No. 301/23
323/14
359/21
826/44

- Subject : Lower mounting of the rudder
- Effectivity : DG-100, DG-200, DG-300, DG-400, all models and all ser.no.'s
DG-500, DG-500M all models up to 5E23
DG-600, DG-600M all models and all ser.no.'s.

No. 301/23 issue 2	No. 348/18 issue 2
323/14 issue 2	843/21 issue 2
359/21 issue 2	370/9 issue 2
826/44 issue 2	866/10 issue 2

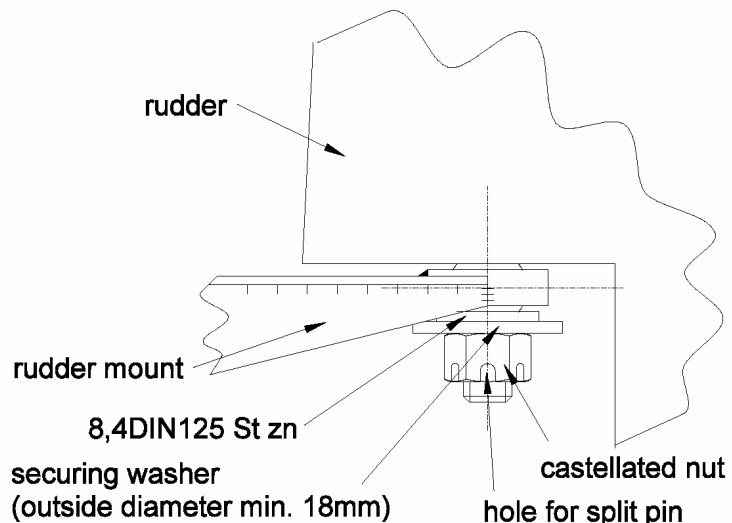
- Reason : On a DG-100 the universal bearing of the lower rudder mounting slipped out of the bearing support and the rudder fell out.
As the design is similar on all DG-types this kind of failure may occur on all DG's.
On later models this connection was secured by an extra securing washer.
Such a washer must be retrofitted to all DG-types with this TN.

- Instructions
1. Check if the outer bearing ring is correctly in place in the rudder mounting, the ring should not be visible.
 2. If the bearing is out of place the rudder mounting must be removed and the bearing must be secured by peening with a chisel or the complete rudder mounting must be exchanged. In addition execute instruction 3 at the same time.

3. Check if a securing washer (min. outside diameter 18mm, 0.71 inch) is installed according to the sketch.
 - a) If yes: The execution of this TN can be entered in the aircraft logs by a licensed inspector without further work to be done.

- b) If no: Remove the castellated nut, install the washer 8.4 DIN9021 and reinstall the nut.
 1. Check if the washer is interfering with the rudder mount. If yes, use a washer 6,4DIN9021 St zn instead, enlarge the 6mm hole to 8mm to enable installation.

2. Check if the split pin can be installed. If yes, secure with a new split pin 2x20 DIN94 zn.If this is not possible, mark the position for a new hole and remove the rudder. Drill a new hole (diameter 2mm, .08 inch) 90° to the existing hole. Reinstall the rudder, use new split pins.
